April 11, 2019

To: Ridgeland WRF Expansion Plan Holders

Re: Addendum #1
Ridgeland WRF Expansion

SHEET NO.
G021
OF
FILE NO.
1636.6

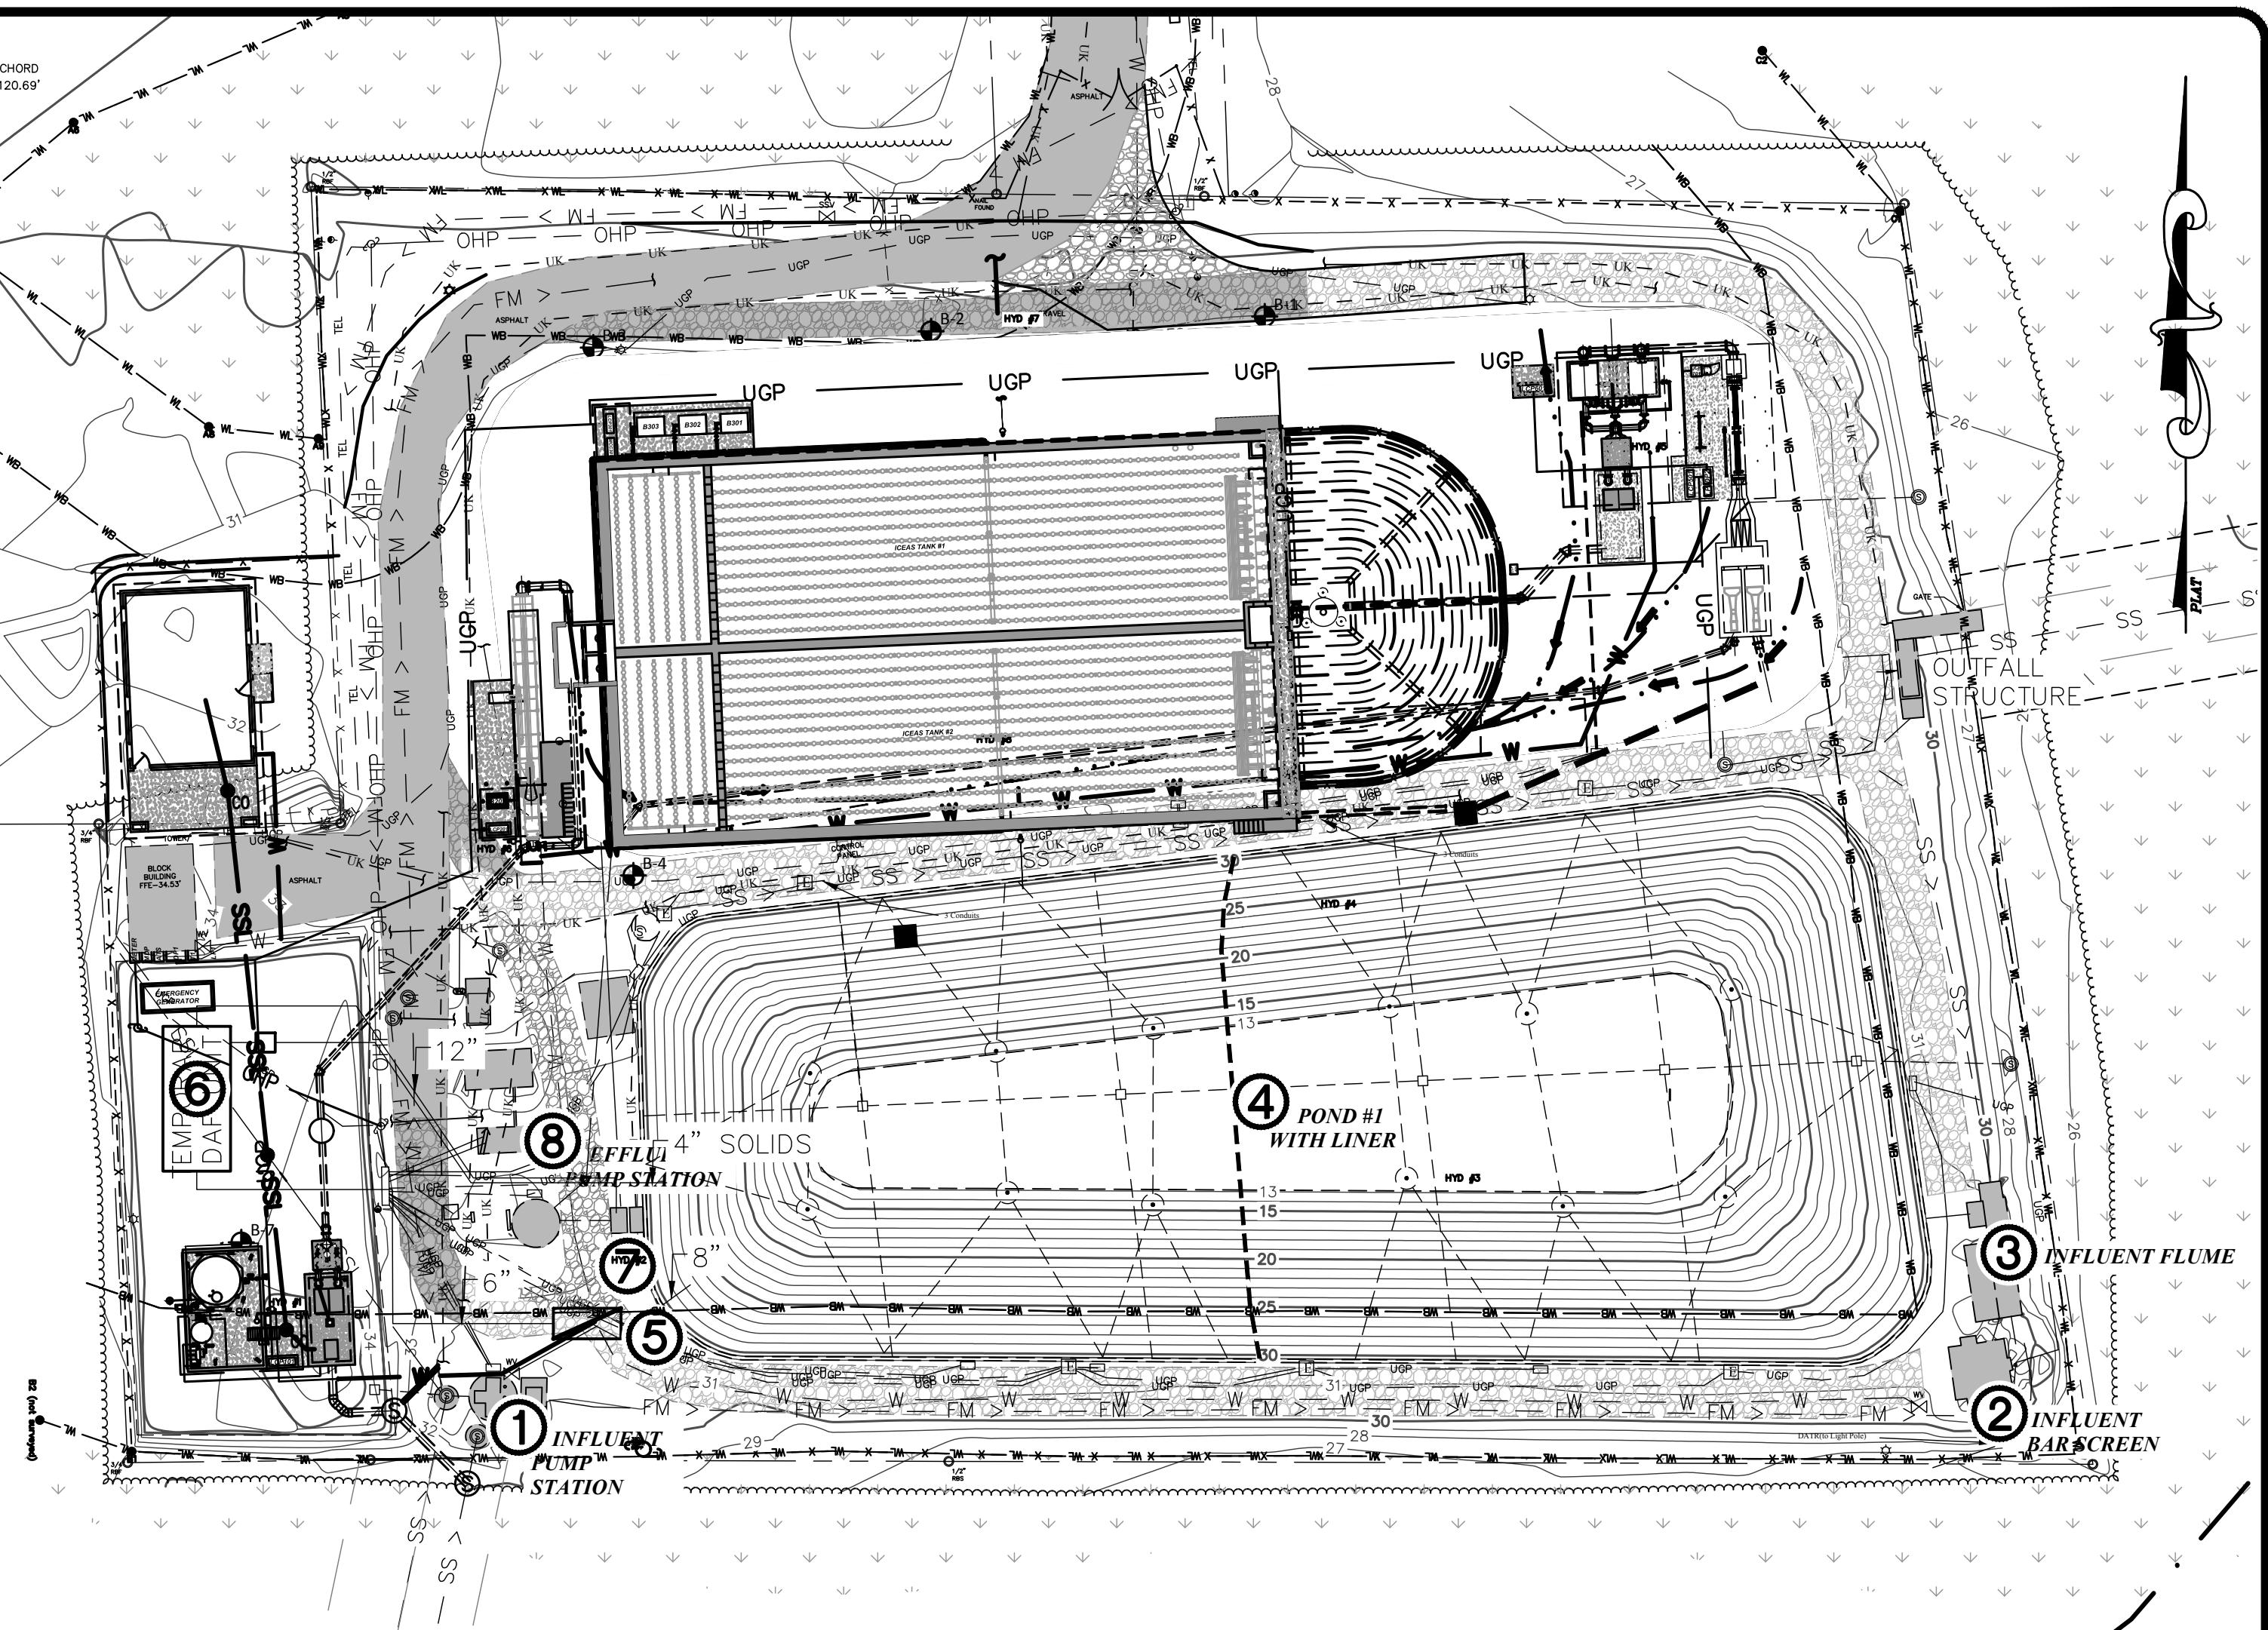
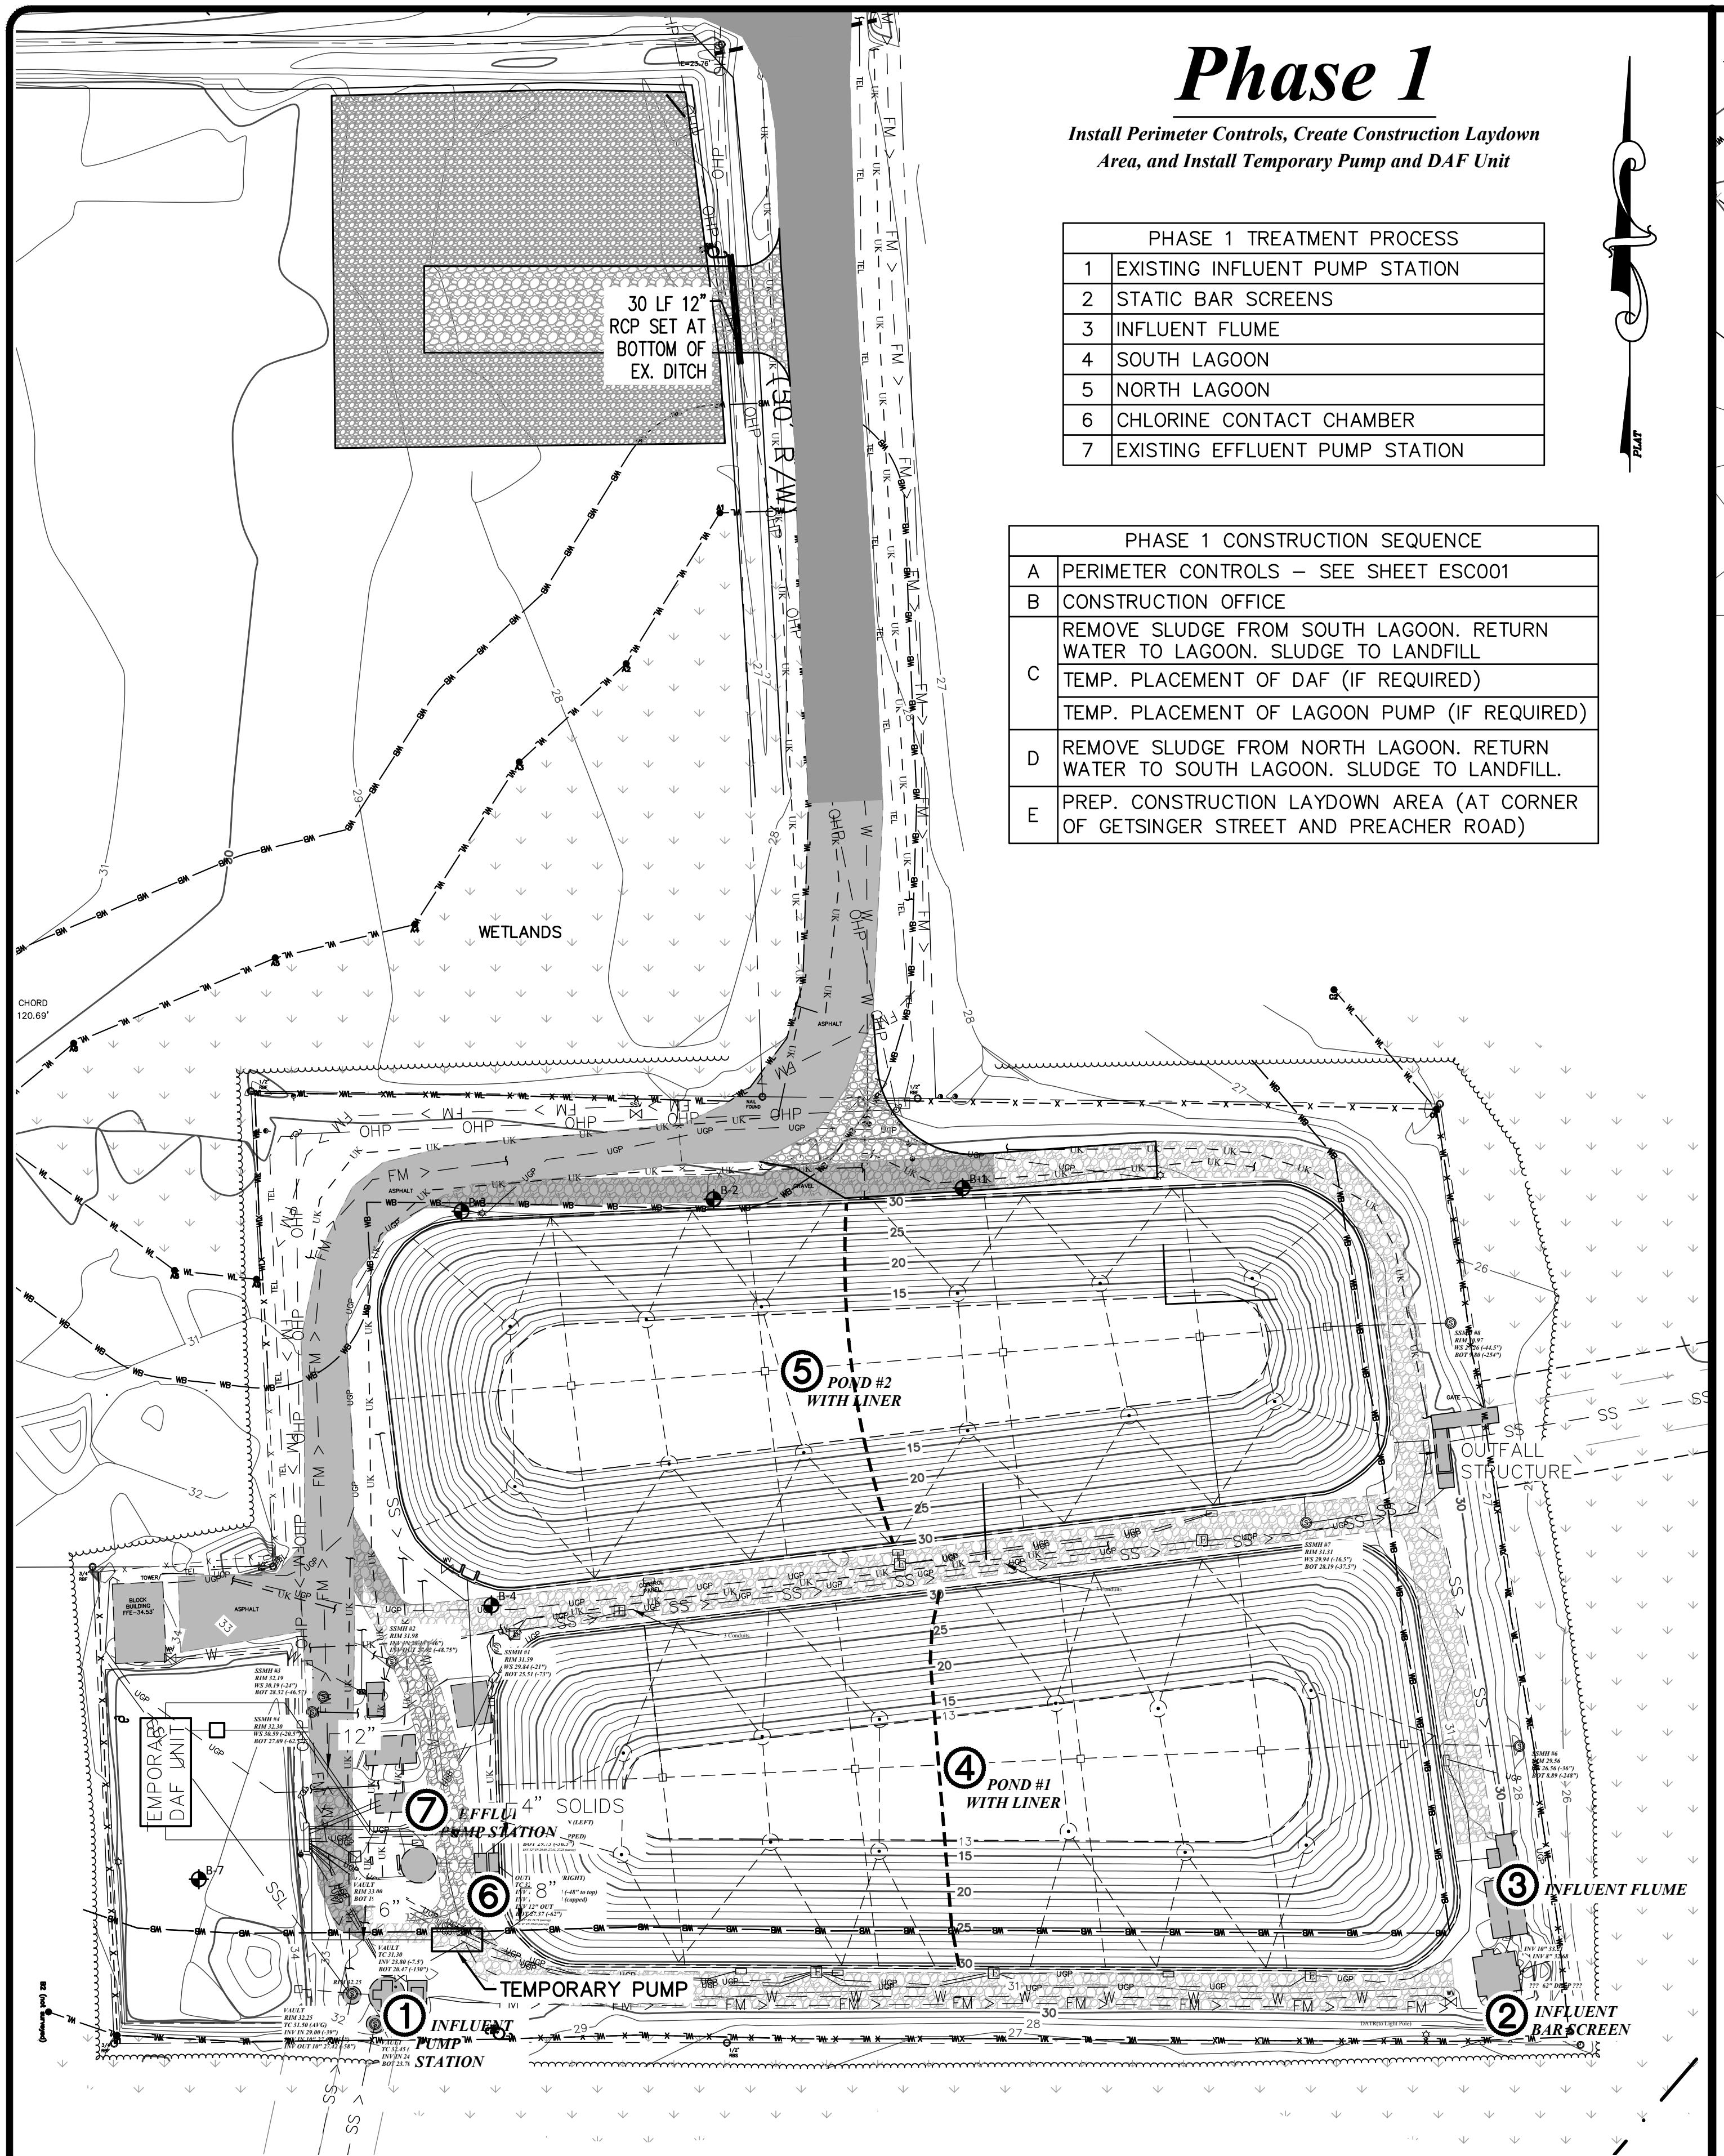
3. The ICEAS tank has been shifted south 21 ft in order to reduce excavation costs. It will remain at its original elevation. The construction sequence is being revised to show the ICEAS Train #1 being constructed and brought on line, then ICEAS #2 being constructed. We are working on the other drawings that show the details of this change, and will get them to you as soon as possible.

- A DIVERT FLOW FROM SOUTH LAGOON TO EFFLUENT PUMP STATION. STARTUP DAF / PUMP SYSTEM (IF REQUIRED)
- B REMOVE NORTH LAGOON LINER. REMOVE OUTFALL STRUCTURE. ICEAS #1 CONSTRUCTION. DRS BUILDING. GRADE DOWN PROPOSED INFLUENT AREA. 1.2
- C EQ POND. FILL AND GRADE AROUND ICEAS #1. INFLUENT PUMP STATION. ALKALINITY ADDITION FACILITY. OPS BUILDING. HEADWORKS. UNIT SLAB. COMBO UNIT INSTALL. SCREEN BYPASS. SPLITTER BOX. ICEAS BLOWERS. PUMP STATION. FILTERS (IF APPLICABLE). JV. POST EQ AERATORS. 1.4. SPLITTER BOX. PARSHALL FLUMES. LAS PUMP STATION PIPING. CREEK OUTFALL PIPING. INSTALL NEW GENERATOR. E PIPING FROM INFLUENT PS TO ICEAS TO JV'S TO CREEK. TEMPORARY SLUDGE HANDLING FOR ICEAS #1. 1.2
